Item 3.**Development Application: 1-5 Flinders Street, Surry Hills - D/2023/119**

File No.: D/2023/119

Summary

Date of Submission:	21 February 2023 (amended plans received 19 July 2024 and 24 October 2024)
Applicant:	Archon Property Pty Ltd
Architect:	David Mitchell Architects
Developer:	Archon Property Pty Ltd
Owner:	Archon Property Pty Ltd
Planning Consultant:	Ethos Urban
Heritage Consultant:	Heritage 21
Design Advisory Panel:	The application was considered by the Design Advisory Panel on 4 May 2023, 26 October 2023, and 23 November 2023.
Cost of Works:	\$5,472,000
Zoning:	E1 Local Centre. The proposed development is permissible with development consent.
Proposal Summary:	<p>The application seeks development consent for internal demolition and alterations and additions to the existing building, including a new three storey plus rooftop addition, to accommodate commercial uses.</p> <p>The application is referred to the Local Planning Panel for determination as contentious development, as it is the subject of 25 or more submissions by way of objection.</p> <p>The application was first placed on public exhibition for a period of 28 days between 16 March and 14 April 2023 in accor

Figure 23: Level 1 demolition plan

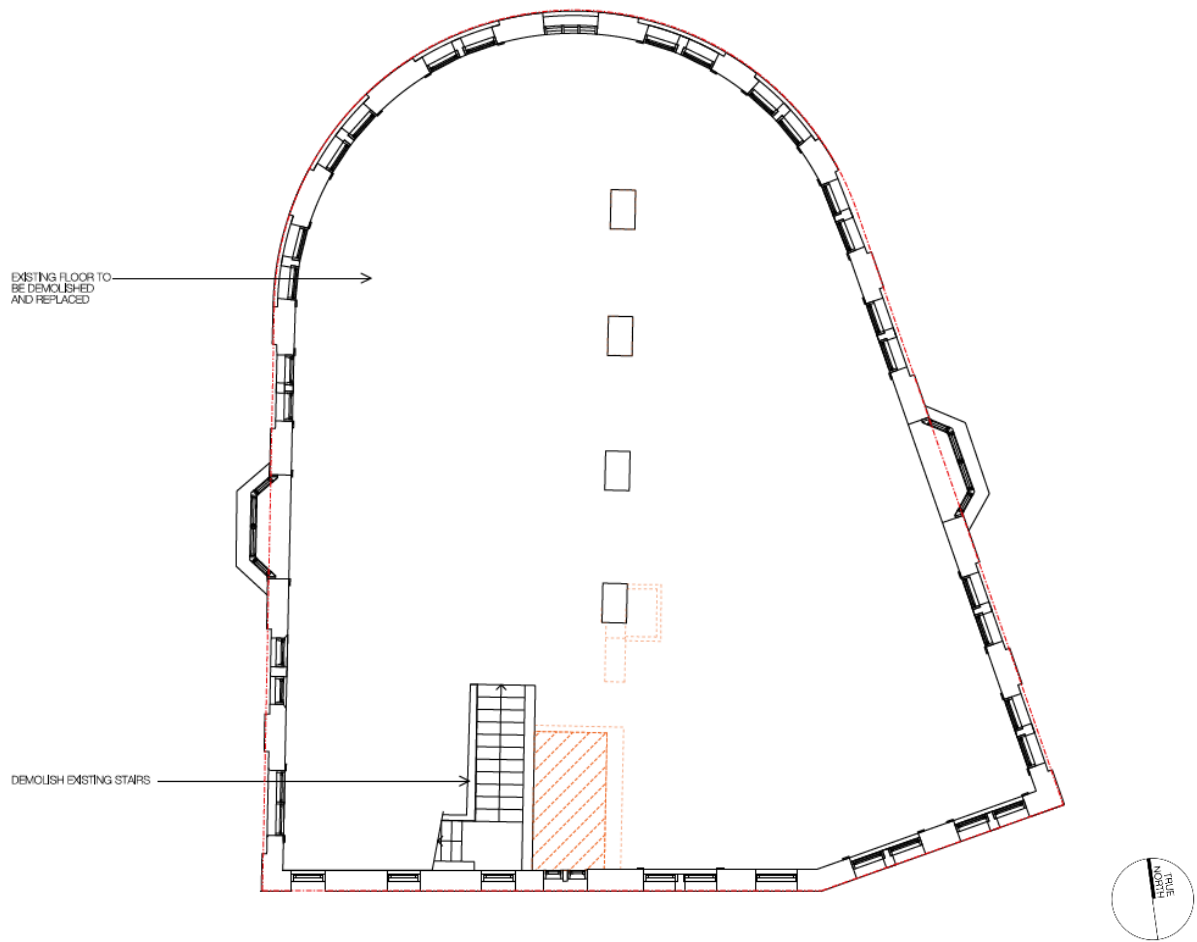
107. The drawings include some inconsistencies, for example the section demolition drawing shows the first floor is to be retained, however the Level 1 demolition plan is annotated to say the floor is to be demolished.
108. A condition of consent is recommended, requiring the plans to be updated following the satisfaction of Deferred Commencement Condition 1 'Final Structural Design within Existing Heritage Building'. In conjunction with Condition 4 'Heritage Design Modifications', this will ensure the plans are clear in terms of the heritage fabric to be retained and incorporated into the design.
109. It is also noted that the section drawings do not demonstrate the extent of any excavation required for lift pits, support columns and the like. A condition of consent is recommended accordingly.

Figure 46: Proposed signage strategy, Taylor Square (north) elevation

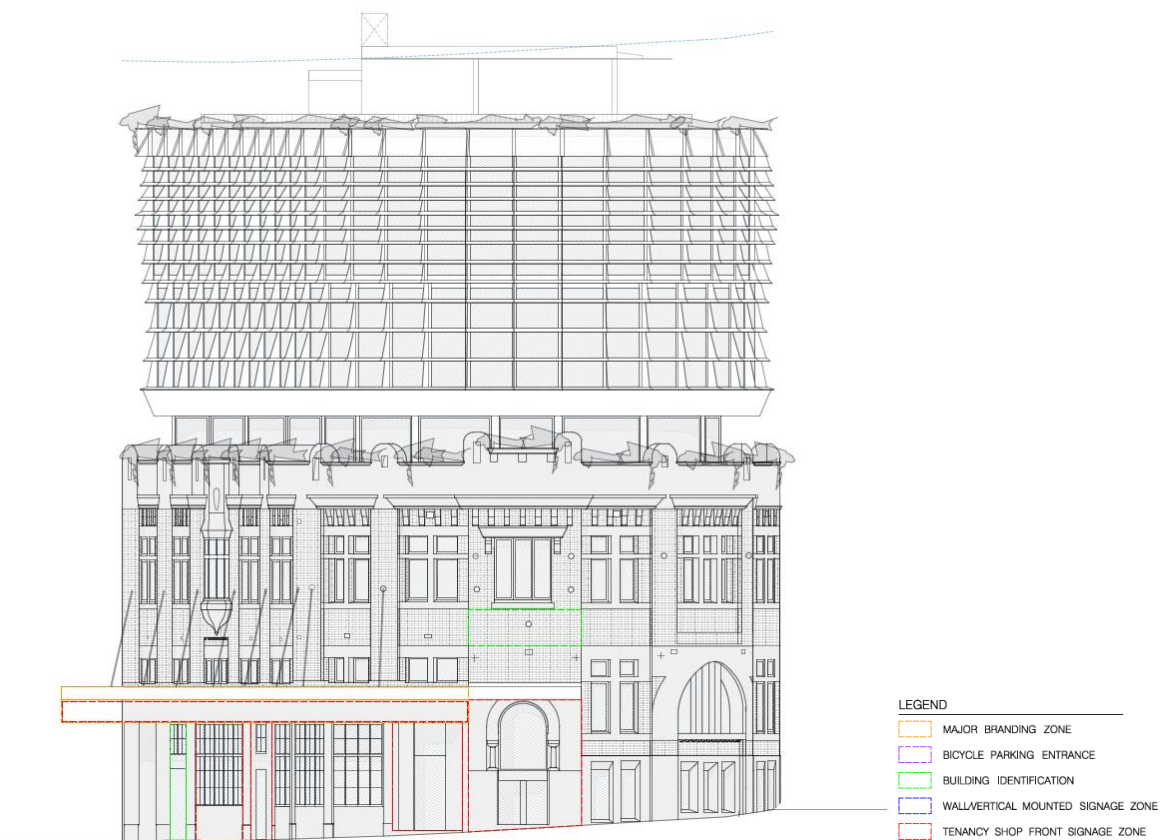
4. Streetscape, setting or landscape	No	The proposed signage is excessive and is not of an appropriate scale, proportion and form. It does not provide a positive contribution to the streetscape and setting of the area and dominates the heritage item.

5. Site and building	No	The scale, and proportion of the proposed signage is excessive. The positioning of some of the signs is unclear as the drawings are inconsistent and, in some cases, show the same sign drawn at different sizes. The proposed materiality is unclear; therefore, it cannot be determined if the signs are compatible with the finishes and colours of the building.

- It includes inconsistencies, for example the projecting wall sign to Patterson Lane is shown as having a height of 900mm on one drawing, and 3.96m on a different drawing.

Figure 66: Preliminary sketch of the now formally proposed Coreten steel frame

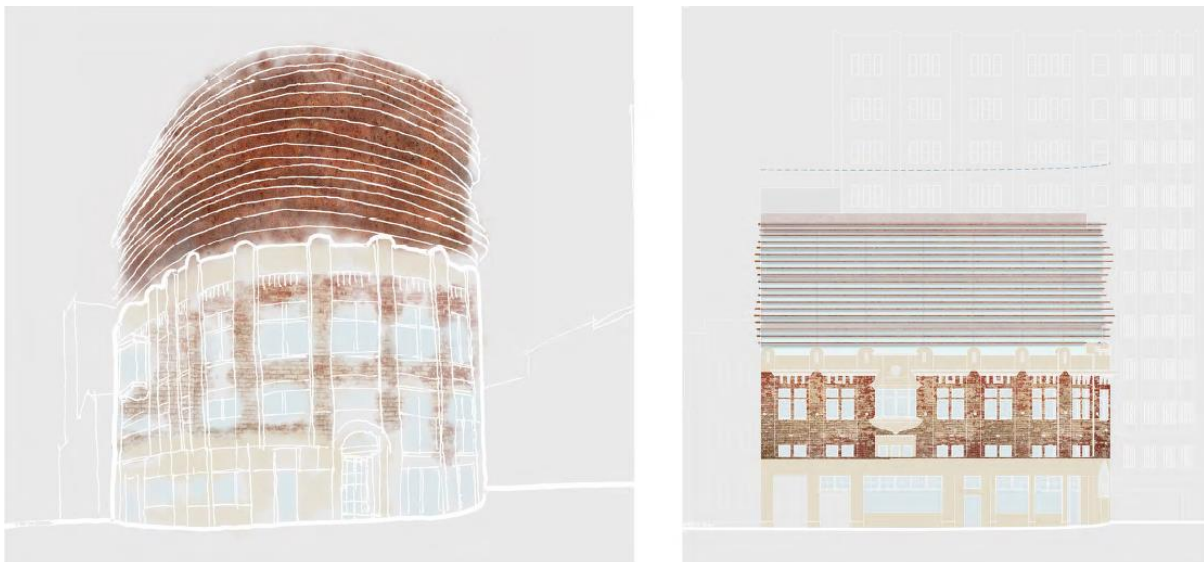
116. The proposal is out of scale with the heritage architecture below. The massing of the proposed addition is in three parts, where a more singular form responding to the original plan would be more successful.

117. The scheme has been amended to provide a more singular form. Level 5 has been deleted from the plans, and the floorplate on Levels 3 and 4 essentially replicates existing Level 1 below. Level 2 provides a recess behind the parapet of the existing heritage building to provide a visual marker to differentiate between the heritage and contemporary components. The design amendments successfully address the concerns of the DAP.
